Intersection ID: 27298	Main Street: CHARTER_HILLS_RD	Cross Street: OWL_NEST_LN	Location:	SW
ADA ID: 8C168B7B94EF	Ramp Type: PerpDiag	Initial Pass/Fail: Fail	Overall Compliance: No	Severity Score: 22.5

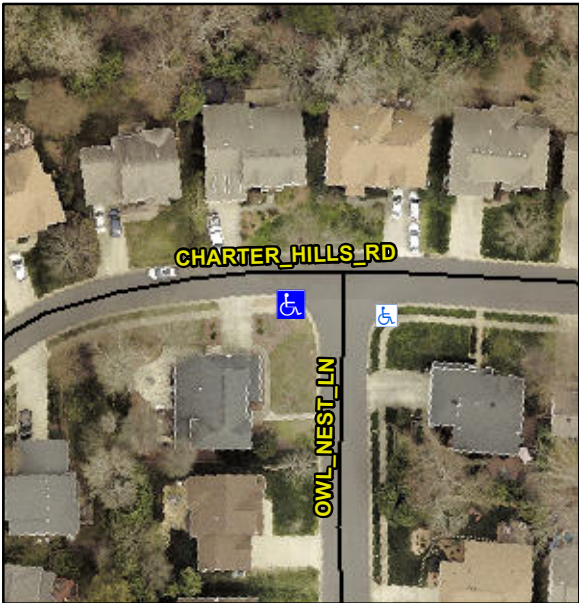
Codes/Mitigation Info/Possible Solution				Field Measurements/Component Compliance					
	Possible Solutions:			Compliance	Description	Data	Compliance	Description	Data
	Remove & Replace Curb Ramp With Two New Directional Ramps or Equivalent.			N/A	Ramp Length (in)	41.0	No	Ramp Slope (%)	8.9
				No	Ramp Width (in)	46.5	No	Ramp XSlope (%)	2.2
				N/A	Flare Type LT	N/A	N/A	Flare Type RT	N/A
				N/A	Flare Slope LT (%)	N/A	N/A	Flare Slope RT (%)	N/A
				N/A	Flare Traversable LT?	N/A	N/A	Flare Traversable RT?	N/A
				N/A	Landing Length (in)	N/A	N/A	DWS Provided?	N/A
				N/A	Landing Width (in)	N/A	N/A	DWS Contrast?	N/A
				N/A	Landing Slope (%)	N/A	N/A	DWS Length (in)	N/A
				N/A	Landing X Slope (%)	N/A	N/A	DWS Full Width?	N/A
Surveyor Notes:	N/A			N/A	Landing Curb? (Y/N)	N/A	N/A	DWS Offset (in)	N/A
				N/A	Shared Landing?	N/A			
	PROW/ADA:			N/A	Gutter Ponding?	N/A	N/A	Gutter Slope (%)	N/A
	R304.5.1, R304.2.2, R304.5.3			N/A	Gutter Lip Ht (in)	N/A	N/A	Gutter X Slope (%)	N/A

N/A	Painted X Walk1?	No	N/A	Painted X Walk2?	No
					X Walk 1 Direction	To E		X Walk 2 Direction	To NE
				N/A	X Walk 1 Width (in)	N/A	N/A	X Walk 2 Width (in)	N/A
					X Walk 1 Slope (%)	3.9		X Walk 2 Slope (%)	3.5
					X Walk 1 X Slope (%)	4.2		X Walk 2 X Slope (%)	1.9
				N/A	Ramp inside XWalk1?	N/A	N/A	Ramp inside XWalk2?	N/A
Street 1 Name	OWL NEST LN				Road Slope (%)	3.7	N/A	Clear Space?	N/A
	Stop Condition-Street 2				Road X Slope (%)	5.8	N/A	Clear Space to XWalk (in)	N/A
	Street 2 Name				Any Obstructions?	N/A	N/A	Storm Grate/Utility Hazard?	N/A
	Stop Condition-Street 1				Obstruction Type			Storm Grate/Utility Type	
						N/A			N/A
							Yes	Surface Condition? (G/P)	Good
Total Cost:			\$	3200.00
